STAFF REPORT
WEST ALLIS PLAN COMMISSION
Wednesday, September 25, 2018
6:00 PM

- 2A. Special Use Permit for a proposed hotel to be located at 1010, 1040 & 1126 S. 70 St., submitted by Kraig Sadownikow, d/b/a 70th Street Hotel Associates, LLC.**
- 2B. Site, Landscaping and Architectural Plans for a proposed hotel to be located at 1010, 1040 & 1126 S. 70 St., submitted by Kraig Sadownikow, d/b/a 70th Street Hotel Associates, LLC. (Tax Key No. 439-0001-026)**

WEST BUILDING ELEVATION

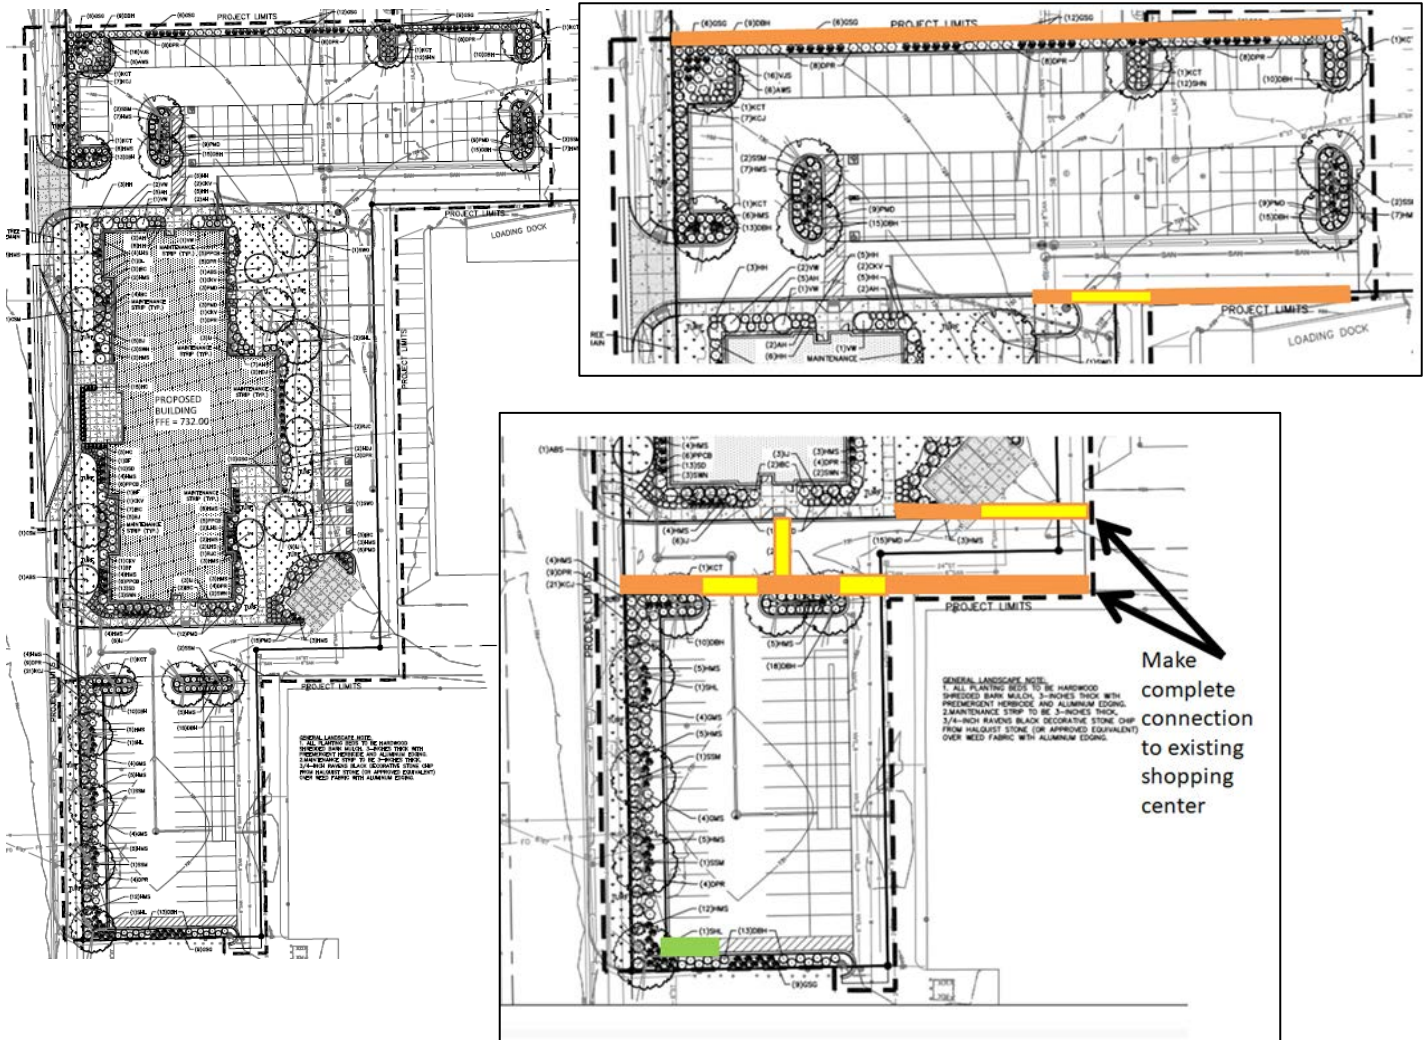
Proposed building materials are comprised primarily of black brick around the base, pewter brick, and pewter hardiepanel siding. Additionally, the Home2 Suites beacon, which indicates the building's main entrance on the east side, will be made with laminated, heat-treated glass in shades of blue and green. In the previously approved architectural plans, a series of full-height metal panel proportions (matching the black brick) were included. This variation has been removed from the current plans, and staff recommends the metal panels be added back in as a primary building material.

Staff recommends additional windows be included on the north and south elevations, as well as to the pool area on the building's east side, to be consistent with the previously approved plans.

1. Revised Site, Landscaping, and Architectural Plans being submitted to the Department of Development to show the following: (a) additional windows added to the north, south, and east elevations; (b) inclusion of metal panels in the building materials; (c) building height details consistent with previously approved plan; (d) PTAC details shown on plan; (e) staff approval of material and color samples; (f) traffic flow; (g) pedestrian travel areas; (h) inclusion of additional sidewalks and pedestrian crossings, as approved by staff; (i) additional landscape area in the southwest corner of the site; (j) adjustments to the refuse enclosure area, as needed; (k) additional streetscape elements (may include lighting, planters, benches, colored concrete, narrowed drives, bump-outs, etc.) which are consistent with overall West Quarter development plans and as approved by staff; and, (l) City Forester approval of the landscaping species and number. Contact Katie Bennett, Lead Planner at 414-302-8463.
